# Final Comments on Model Validation Report

## E. Adams, July 2006

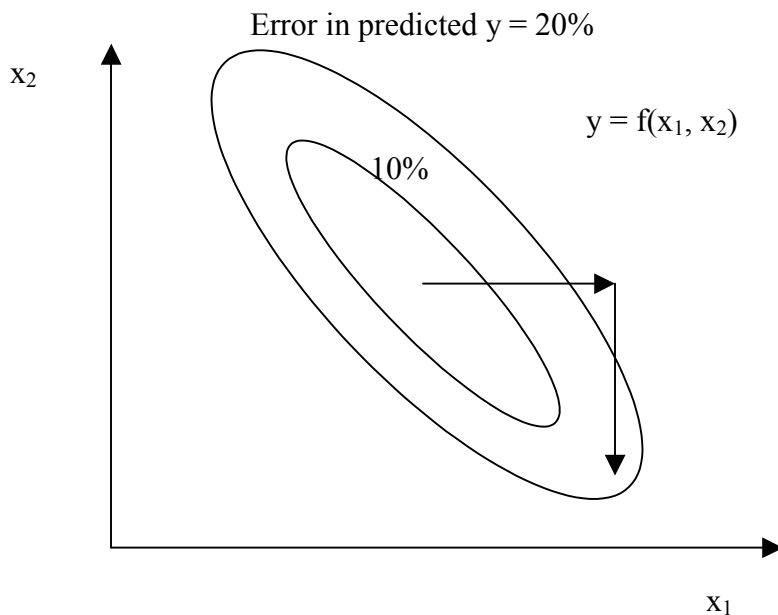
While the model shows substantial sensitivity to diffusion parameters during low flow at New Lenox Rd, GE points out that virtually no sensitivity is indicated at Woods Pond Footbridge. Since the flow must pass from NLR to WPF, this is illogical. Unless there is a mistake in plotting (and EPA suggested there was not), this could indicate a potential problem in model formulation.
